Subject: Modification of the airbrakes

Concerned: G 103C TWIN III ACRO, S/N's 34171 - 34185

**Anmerkung zur TM 315-55!
Note to Service Bulletin
TM 315-55!**

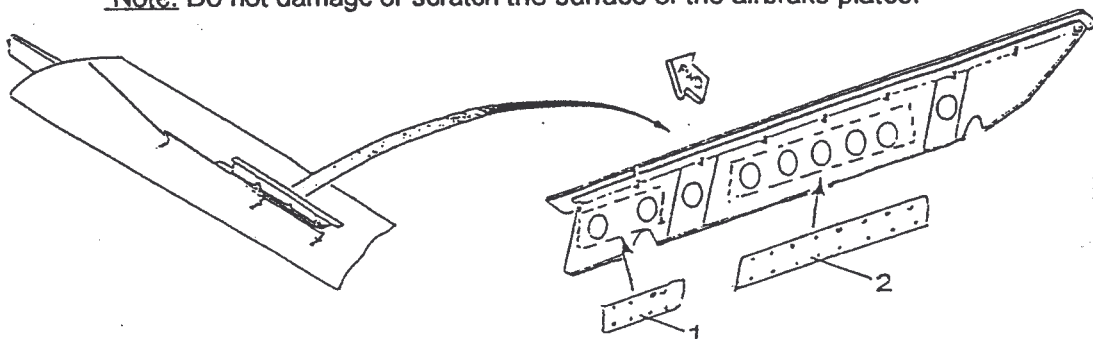
Procedure: Airbrakes with holes in the airbrake plates are installed in the sailplanes with the above S/N's, contrary to the type specification. To assure the airbrake efficiency in the speed range of V_{NE} , a modification to the airbrakes is mandatory.

Actions: The airbrake plates must be modified as follows (hole blanking):

1. Extend airbrakes fully, lock airbrakes and secure against unintentional retraction.
2. Position blanking plates from the front (smaller [1] inboard, larger [2] outboard) on the airbrake plates (10 mm below and 10 mm left or right of the edge of the holes) and secure blanking plates (note the countersunk holes in the blanking plates face forward!).

3. Drill the airbrake from the holes in the blanking plates using a 3.1 \varnothing drill. Remove blanking plates and clean.
4. Rivet the blanking plates with aluminium countersunk rivets, size 3x8.
5. Clean airbrake box from swarf and all foreign objects.
6. Perform function test of airbrake control.

- drill the airbrake plates using a 3.3 \varnothing drill
- rivet the blanking plates with rivets, size CCR 264CS4-4

- drill the airbrake plates using a 3.3 \varnothing drill
- rivet the blanking plates with rivets, size CCR 264CS4-4
